ADDENDUM #3

CITY HALL HVAC UPGRADE

BID #14/15-008 – PWP# WA-2015-012

**SPARKS CITY HALL
 CAMPUS HVAC UPGRADE
 SPARKS, NEVADA**

SHEET NUMBER :
E1.1

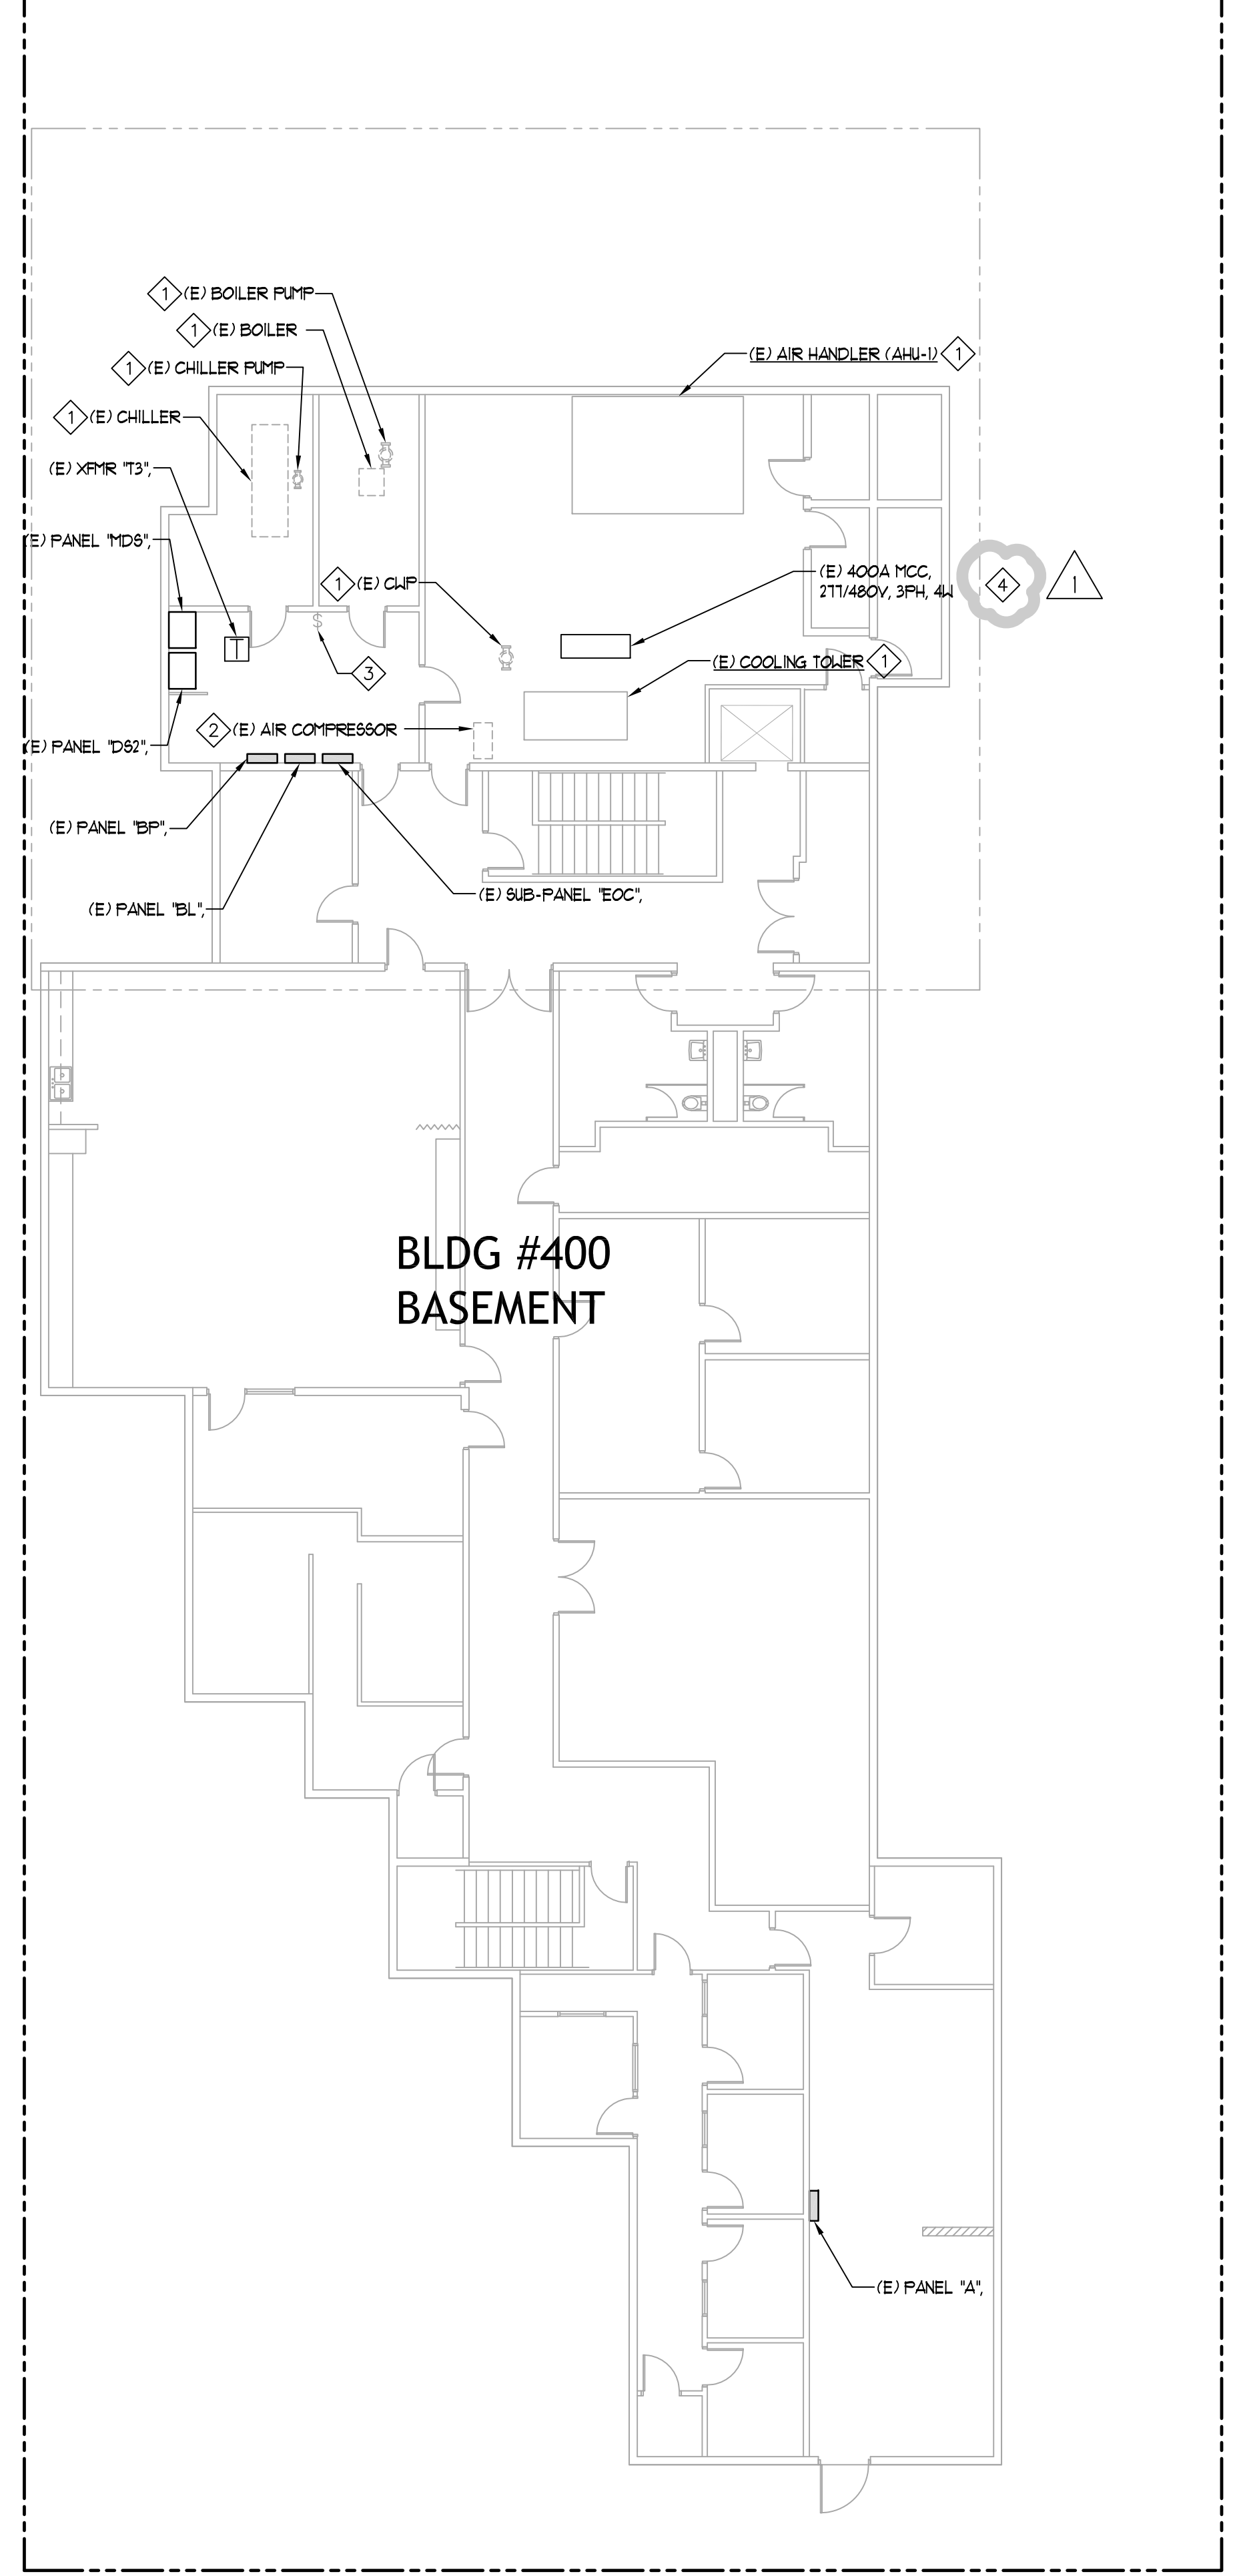
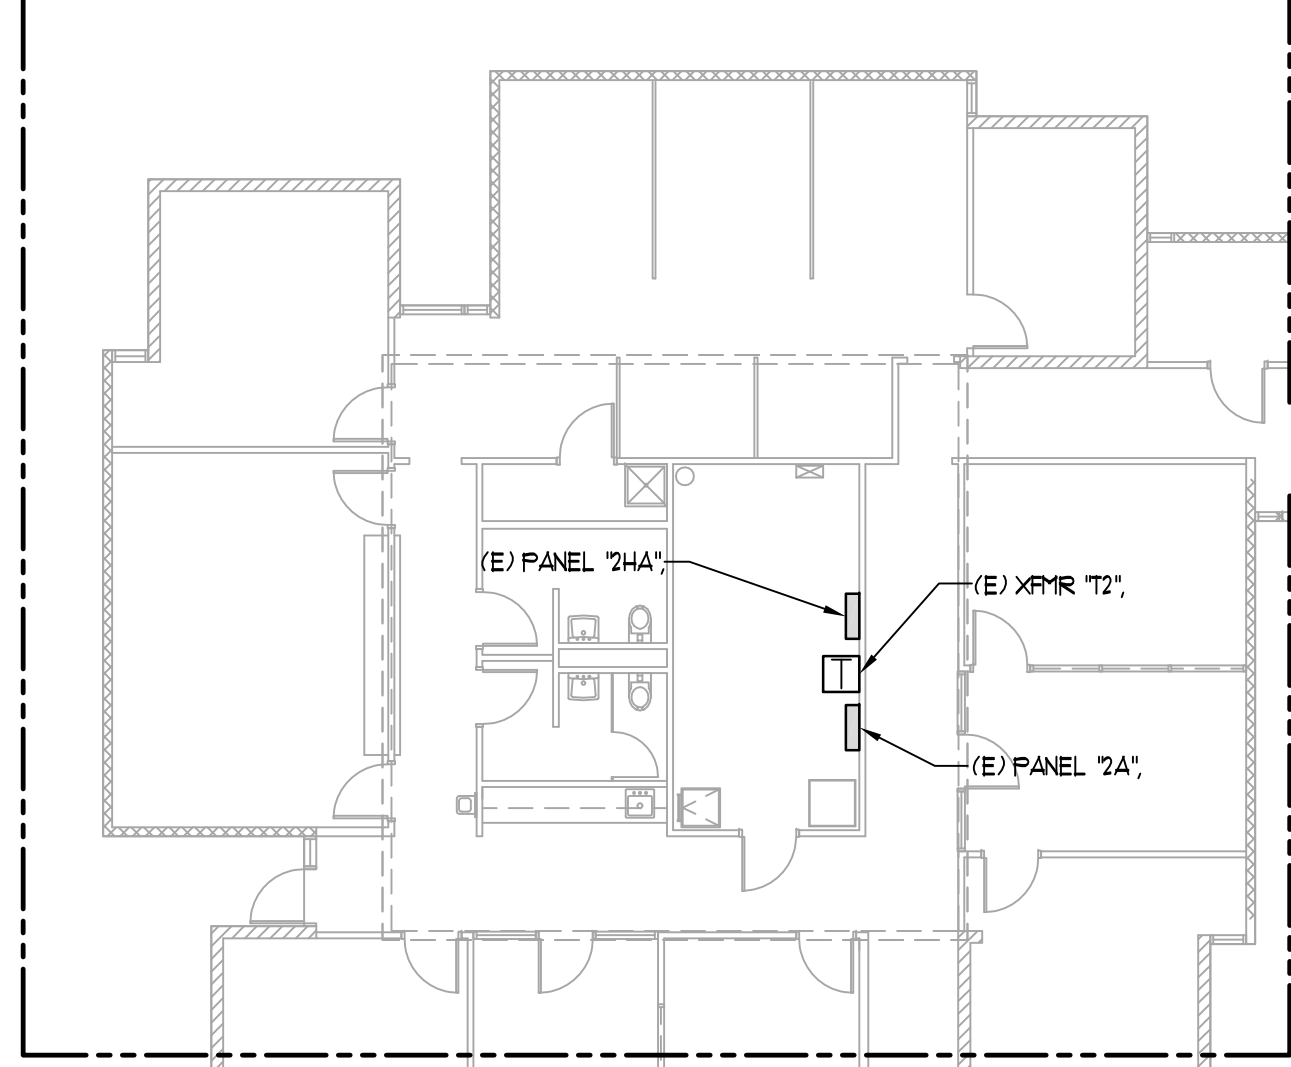
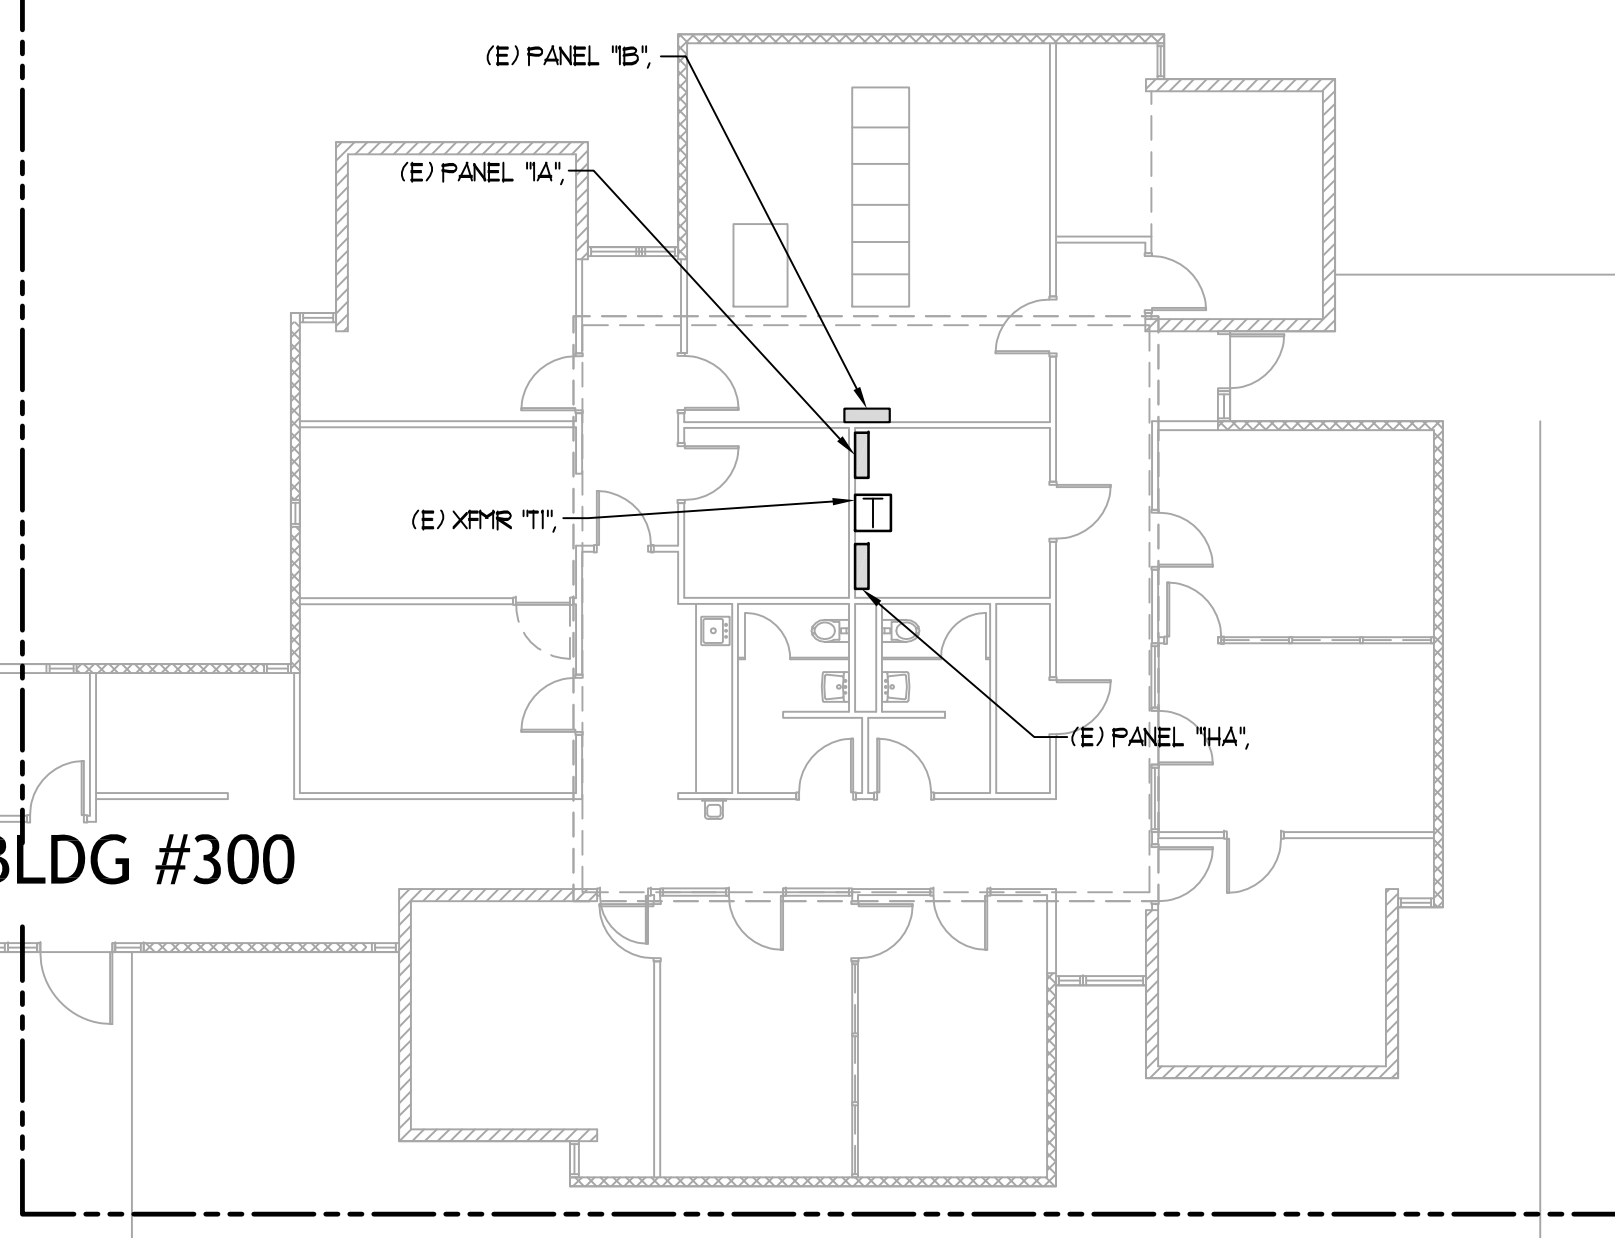
IF ALTERNATES #1-#4 ARE NOT ACCEPTED THEN AHU'S WILL REMAIN CONNECTED TO EXISTING MCC.

- Ⓢ ELECTRICAL CONTRACTOR TO DISCONNECT ALL ELECTRICAL CONNECTION TO MECHANICAL EQUIPMENT. CONDUCTORS TO BE REMOVED BACK TO PANEL CONDUIT TO BE REUSED. CONTROL WIRING REMOVAL TO BE COMPLETED BY MECHANICAL'S CONTROLS CONTRACTOR.
- Ⓢ ELECTRICAL CONTRACTOR TO DISCONNECT AND REMOVE ALL CONDUCTORS AND CONDUIT TO PANEL. (IF ALTERNATES 1-4 ARE NOT ACCEPTED THEN THE AIR COMPRESSOR WILL BE RELOCATED AND RECONNECTED)
- Ⓢ RELOCATE BOILER SHUT DOWN SWITCH. SEE SHEET E1.3 NOTE 3 FOR NEW LOCATION.
- Ⓢ IF ALL ALTERNATES ARE ACCEPTED THEN MCC WILL REMAIN OPERATIONAL DURING CONSTRUCTION AND WILL BE REMOVED AFTER ALL EQUIPMENT CONNECTIONS ARE DISCONNECTED FROM MCC. REMOVE MCC FEEDER AND EXPOSED CONDUIT WHEN MCC IS REMOVED.
